Studebaker

# SERVICE BULLETIN

NO. 247

## SERVICE DATA - H AND IOG MODELS

7. **EXHAUST PIPE CLAMP U-BOLT POSITION - MODEL H**

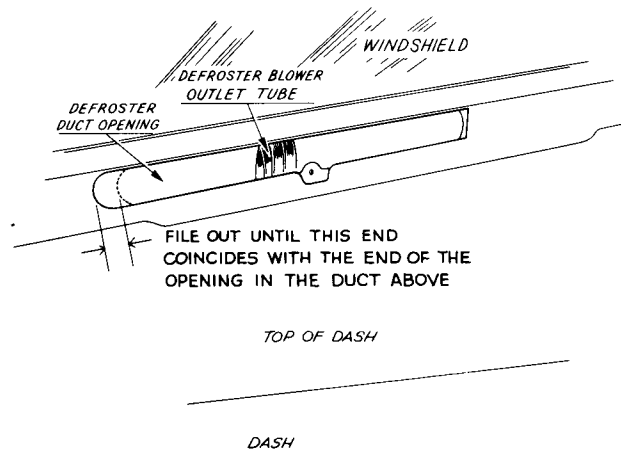
On early production 1951 Commander models, there is a possibility the exhaust pipe clamp U-bolt may have been improperly positioned. This exhaust pipe clamp U-bolt should be positioned so that the nuts are upward toward the engine block. This is important since the open end of this U-bolt, if pointing downward, may interfere with the steering bell crank.

You should check all 1951 Commanders thus far received to determine if this U-bolt is properly positioned. If it is not, loosen the nuts and move the U-bolt and the saddle until the correct position is reached as shown in the accompanying drawing. Then, retighten the nuts.

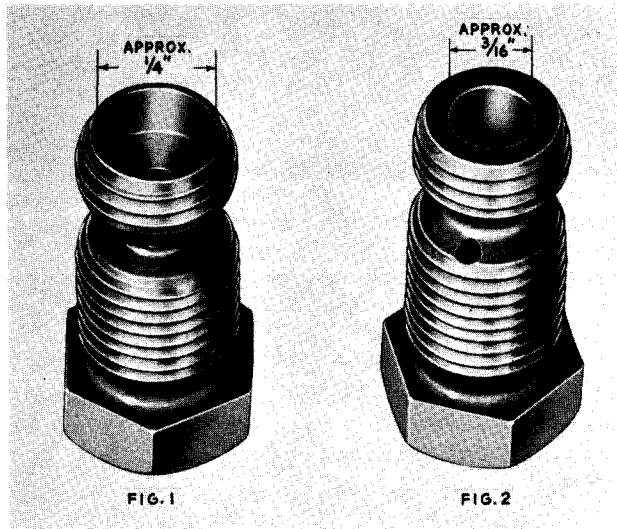
Conditions of too narrow a pattern of frost or mist removal from the windshield by the defroster on 1950 models may be caused by an excess of metal on the air duct panel overlapping the outside edge of the defroster air duct (see illustration).

8. Remove the right and left lower glass channel retainers.
9. File the outer ends of the defroster duct opening as required to match the opening in the glass channel retainer (see illustration).

FIG. 1

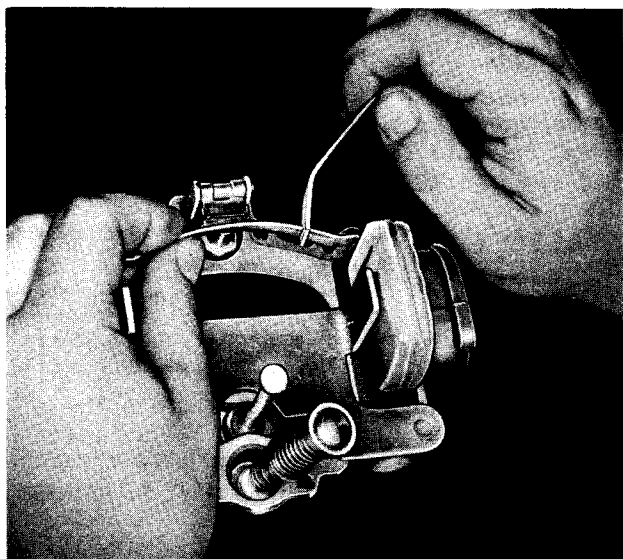
The procedure for setting the float on the Stromberg Model AAQVB-26 carburetor used on Commander V-8 engines has been revised. To set the float level in this carburetor proceed as follows:

Place the Float Gage T-24971 on the cover gasket with the two lugs of the tool seating in the corresponding holes in the air horn. Using Tool KMO-269-S5, bend the float arms as necessary so that the floats are parallel to the vertical guides of the tool (see Fig. 1).

FIG. 2

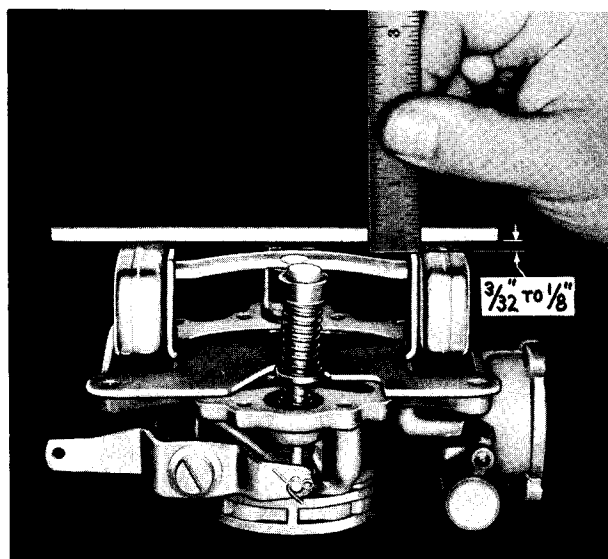
Then, check the setting of each float. Place a straight edge across the highest point of the floats and measure the height of the floats above the vertical guides of the tool (see Fig. 2). This measurement should be from  $3/32''$  to  $1/8''$  (2,38 to 3,18 mm.). Both floats must be at the same height. With Tool KMO-269-S5 bend the float arms as required to obtain the proper float setting.
